ENGINE - LP COMPRESSOR - PROVIDE IDENTIFICATION FOR LPC/ INTERMEDIATE CASE MODULE -
CATEGORY CODE 6 - MOD.ENG-72-0171

V2500-ENG-72-0171

Reidentification of the new module identification plate
Fig.1

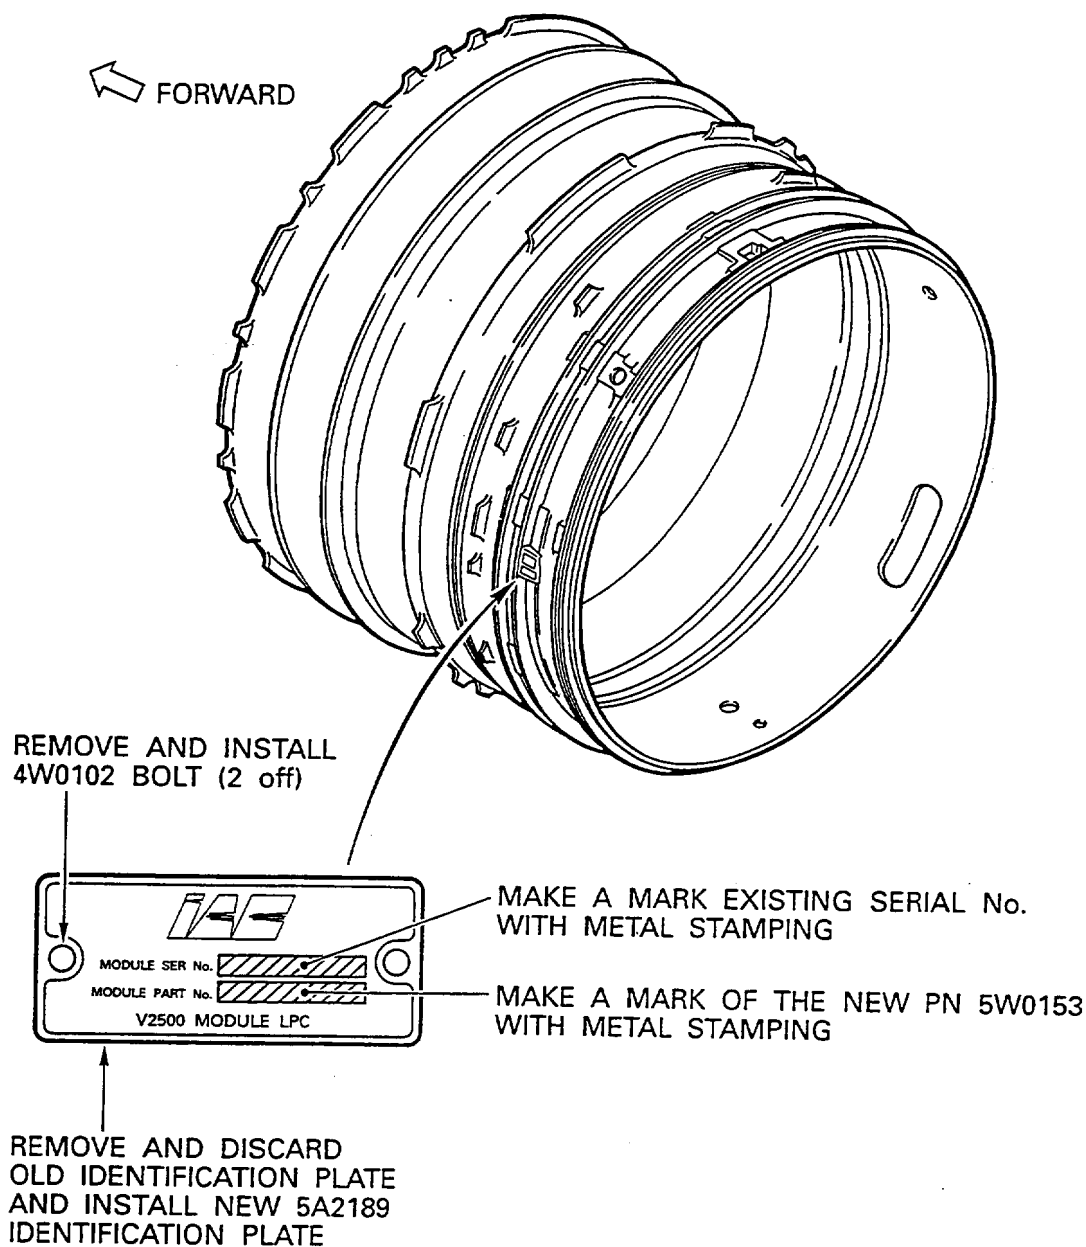
To correct the module assembly number (module identification number) marked on the LP Compressor/Intermediate Module which have incorporated Service Bulletin V2500-ENG-72-0150 in production.

The module serial described in the Effectivity paragraph have incorporated modification (Service Bulletin V2500-ENG-72-0150) and been identified by the incorrect module assembly numbers in production.

- (1) Find the existing Module Identification Plate on the LP Compressor/Intermediate module and make sure that Module Assembly Number is 5W0142.
- (2) Replace the Module Identification Plate as follows (Refer to Figure 1):
 - (a) Remove the existing 4W0102, two bolts from the module identification plate on the fan case.
 - (b) Remove the existing module identification plate and discard it.

NOTE: Make sure the existing serial number on the module identification plate before you discard it.

- (c) Make a mark of the new module assembly number 5W0153 and existing serial number to the new 5A2189, module identification plate by the approved procedures in Reference (1), Chapter/Section 70-09-00, Marking of Parts.
- (d) Install the marked new module identification plate with the two 4W0102, bolts in to sufficient position.
- (e) Torque the bolts to 36 to 45 lbfin (4,00 to 5,00 Nm).
